14 Lincoln Place Cinema Building, Madison, NJ

Structural Review

Thornton Tomasetti Project No. F19022.00

February 8, 2019

Photo 1: Roof Joists on Sloped Roof: Note significant deflection (typical), and cracked joist at arrow.

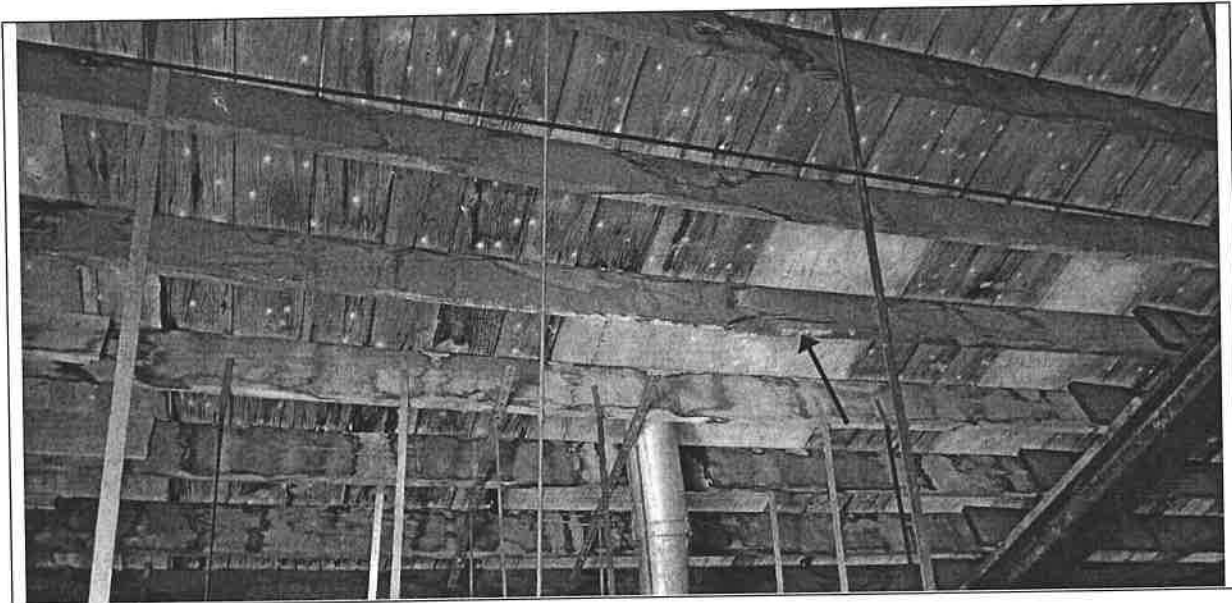
1. *Sagging/Cracked Roof Joists on Sloped Roof:* The wood roof joists that span to the steel roof trusses are significantly deflected, and in some instances are cracked. Refer to Photo 1. —

The joists appear to be sagging as a result of short term and long term (creep) deflections under the weight of the roof structure and plaster ceiling suspended from the joists. These 2x10 joists span 17', which is unusually long for this joist size. TT structurally analyzed the joists and found that they would be significantly overstressed when carrying code prescribed snow loads.

1. *Sagging/Cracked Roof Joists on Sloped Roof:* The significantly deflected and overstressed joists on the sloped roof are structurally deficient and should be removed and replaced. This would also require removing and replacing the roof sheathing and shingles, and temporarily supporting the suspended plaster ceiling.

Photo 2: East Exterior Wall: Note significant structural diagonal cracks.

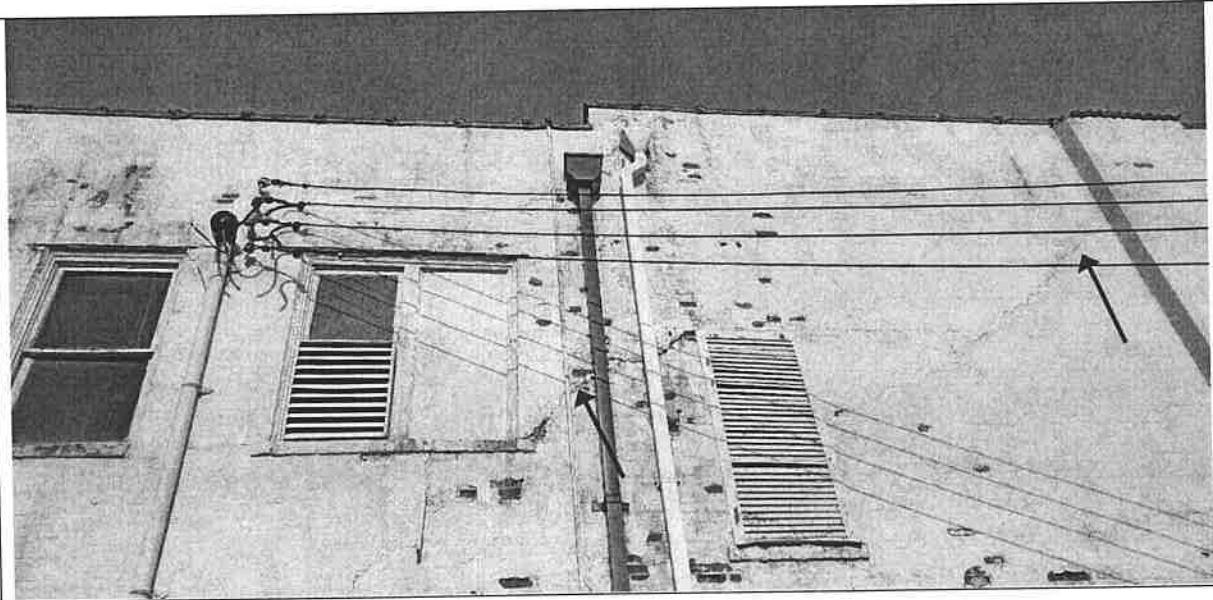
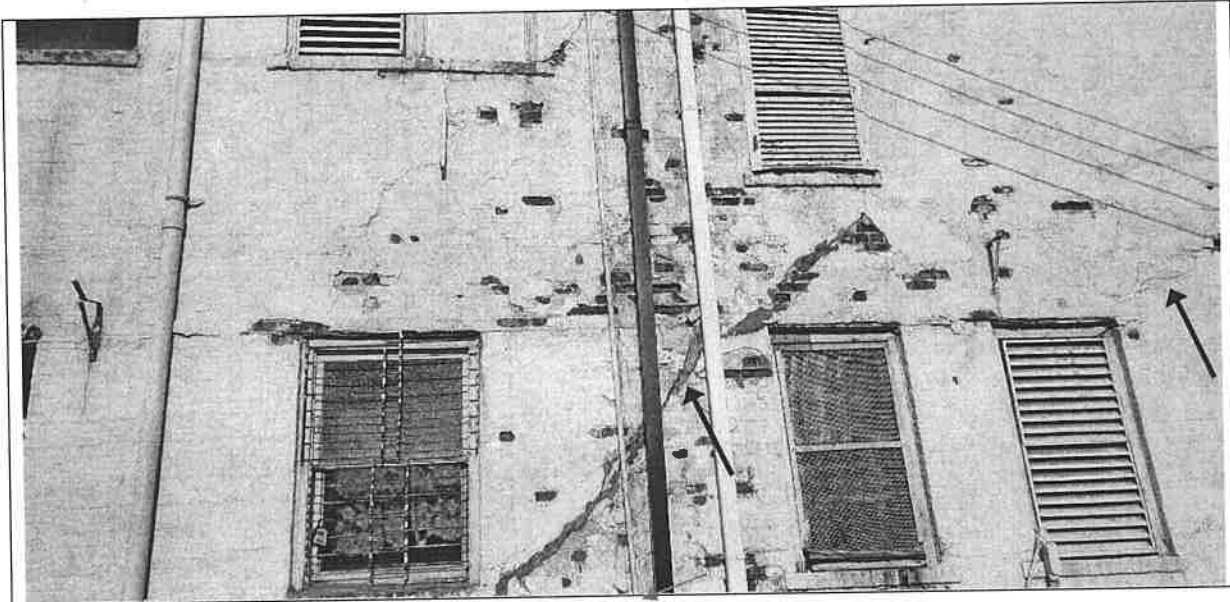
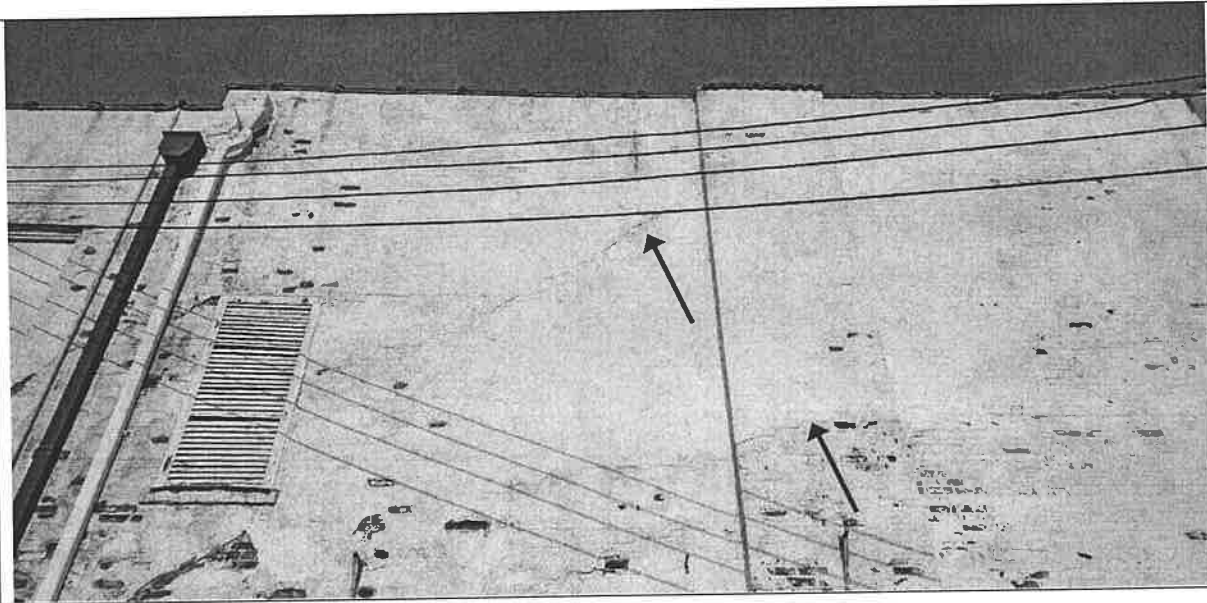
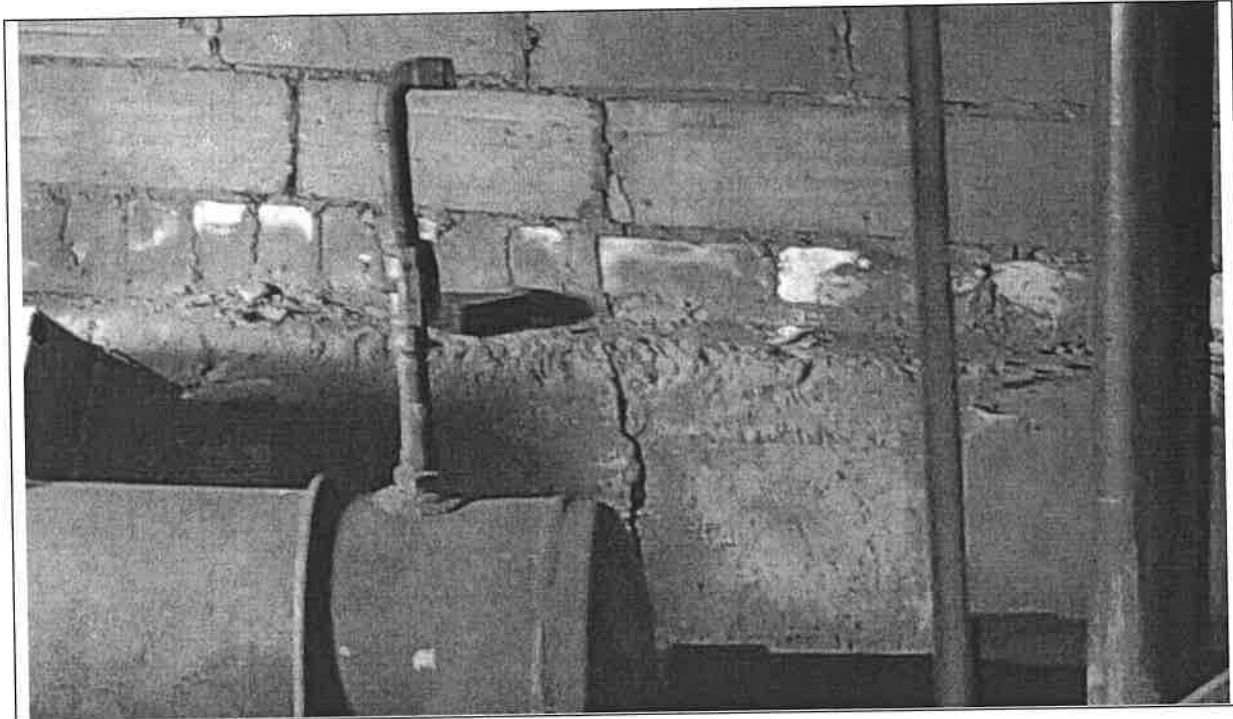
3. *Structurally Cracked Section of East Exterior Wall and Supporting Concrete Foundation:* A large section of the east exterior wall has a number of structural diagonal cracks from bottom to top of the wall, including through the brick piers that support the roof trusses, and through the concrete foundation itself. Refer to Photos 2 – 4, and 10.

The configuration and size of these structural cracks indicate that a portion of the supporting wall foundation has settled. The observed cracking and settlement have structurally compromised: 1) a substantial section of the east wall, which laterally stabilizes the building; and 2) a brick pier that supports a roof truss.

3. *Structurally Cracked Section of East Exterior Wall:* The soil under the wall's foundation should be investigated with test pits and soil borings to determine whether the wall is at risk of continuing settlement. If necessary, the foundation should be stabilized with soil grouting, mini piles or

other suitable means. Regardless of whether foundation stabilization is required, the cracked masonry should be selectively removed and replaced.

Photo 6: East End of Interior Bearing Wall below South Gable: Note significant structural cracks.

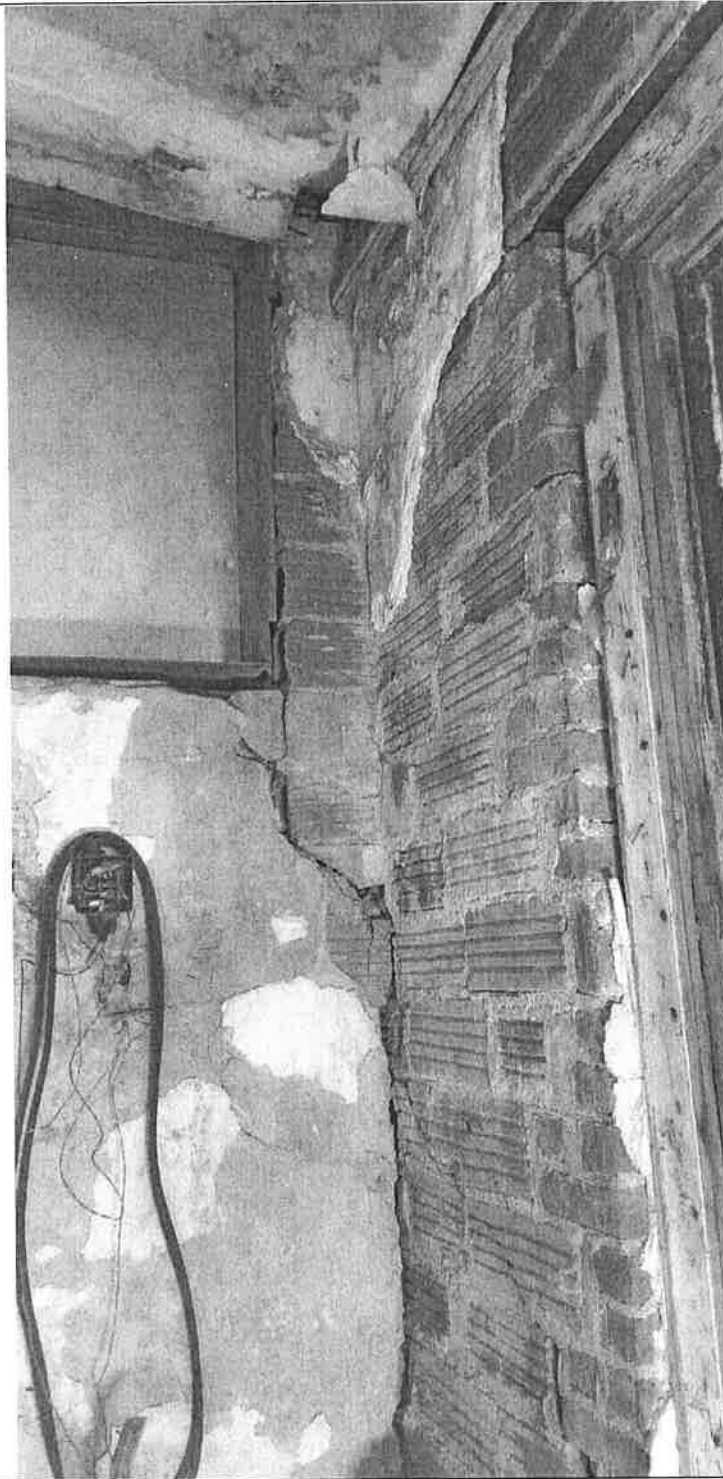
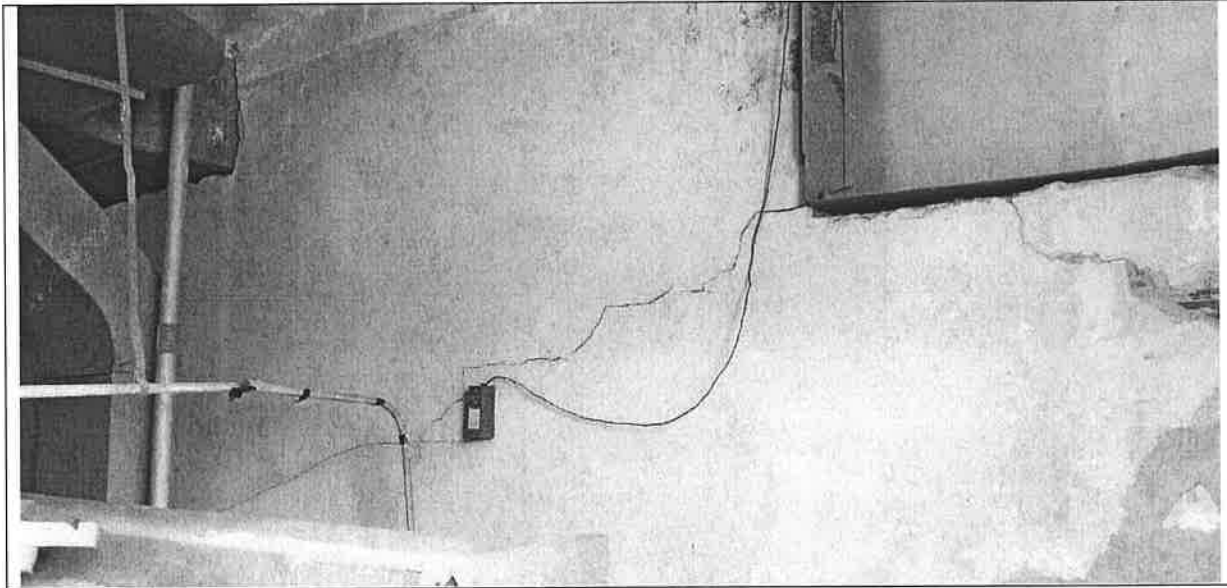
4. *Structurally Cracked Section of East Side of Interior Bearing Wall:* A large section of the interior bearing wall below the south gable of the sloped roof is structurally cracked near the east side. Refer to Photos 5 – 6.

The size of these structural cracks and proximity to the settled section of the east exterior wall suggest that this section of wall may have been damaged by foundation settlement as well. The

observed cracking has structurally compromised the end section of this wall, which laterally stabilizes the building and provides vertical support for the roof.

4. *Structurally Cracked Section of East Side of Interior Bearing Wall:* The soil under the wall's foundation should be investigated with test pits and soil borings to determine whether the wall is at risk of continuing settlement. If necessary, the foundation should be stabilized with soil grouting, mini piles or other suitable means. Regardless of whether foundation stabilization is required, the cracked masonry should be selectively removed and replaced.

Photo 7: End of Interior Bearing Wall at Face of East Exterior Wall – Note separation indicative of out of plane wall displacement.

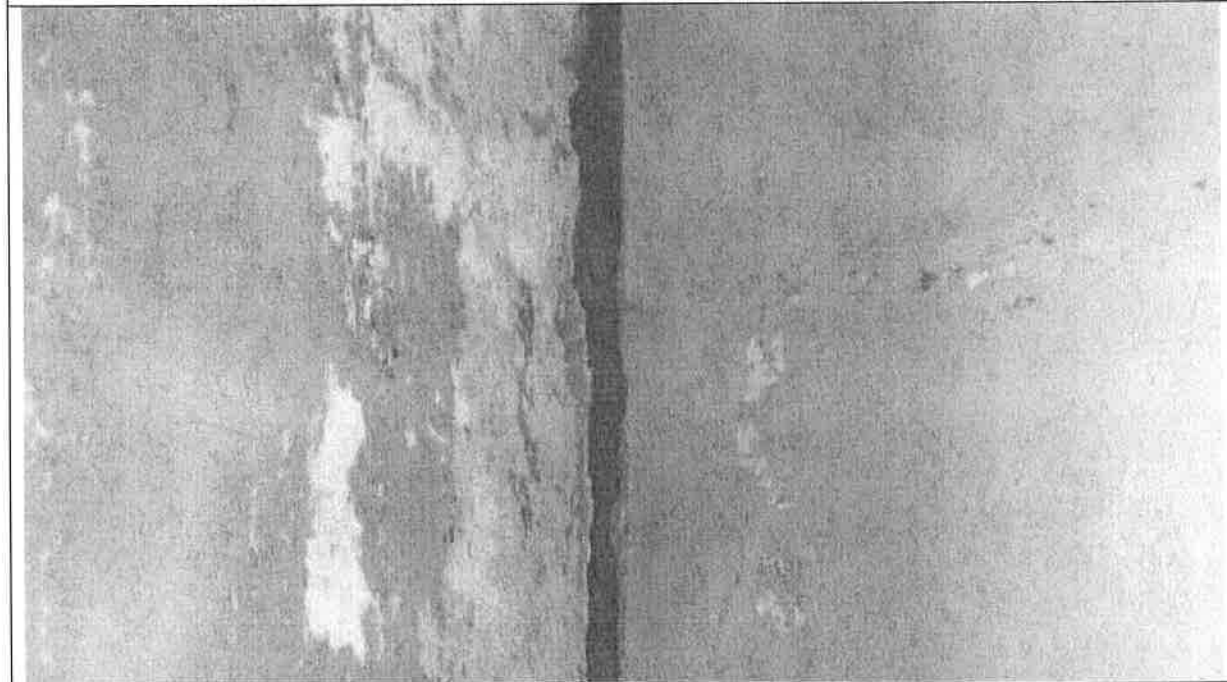
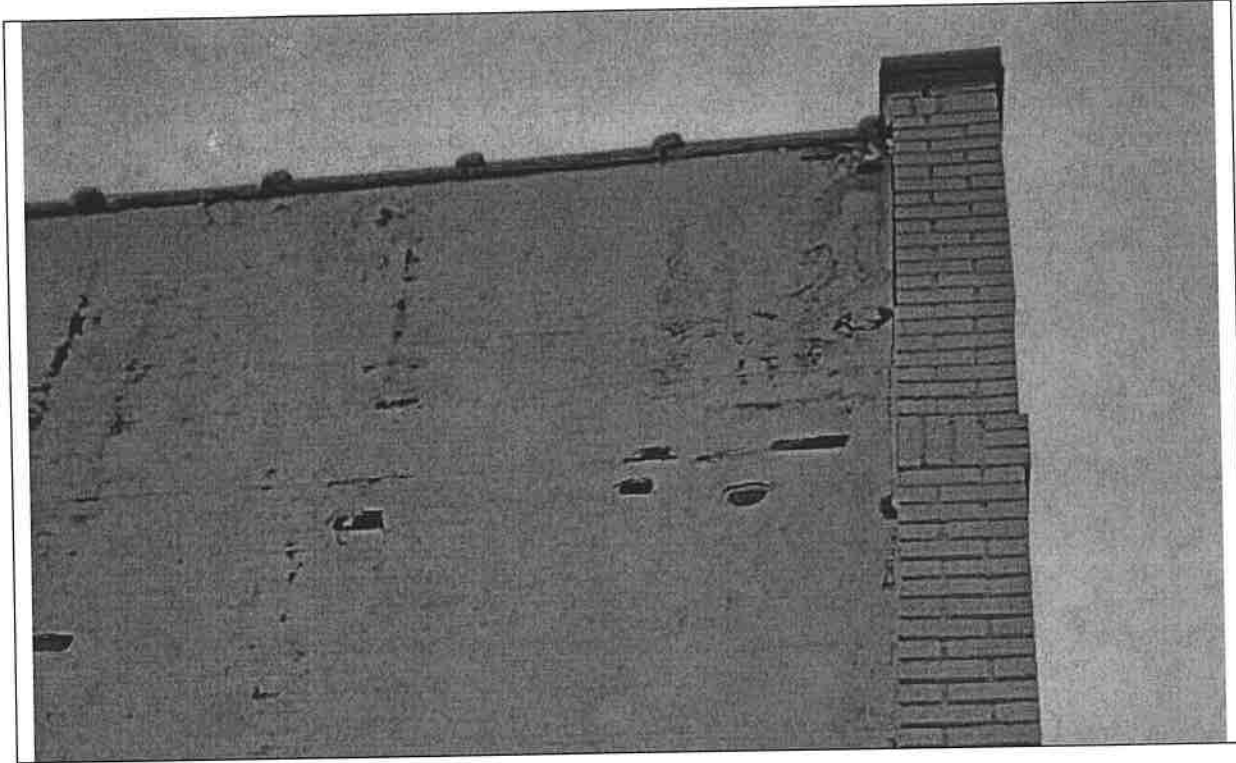
5. *Out of Plane Displacement and Cracking of Exterior Walls:* TT and Persimmon observed a number of locations where the exterior walls have displaced outward at their tops as evidenced by the walls separating from perpendicular walls. Refer to Photos 7 – 8. Locations were also observed where the exterior walls/piers have horizontal cracks. Refer to Photo 9.

The observed displacements indicate that the walls are not adequately anchored at their tops to resist out of plane forces. The observed horizontal cracks may be an indication that the walls are bowing outward between horizontal anchor points at the foundation and roof. These displacements and cracks have structurally compromised the exterior walls, which laterally stabilize the building and provide vertical support for the roof.

5. *Out of Plane Displacement and Cracking of Exterior Walls:* The out of plane displacement and cracking should be investigated and stabilized as required by adding anchors to better tie the walls back to the roof structure and perpendicular walls, and by reinforcing the brick piers to better resist out of plane forces. *How much out of plane*
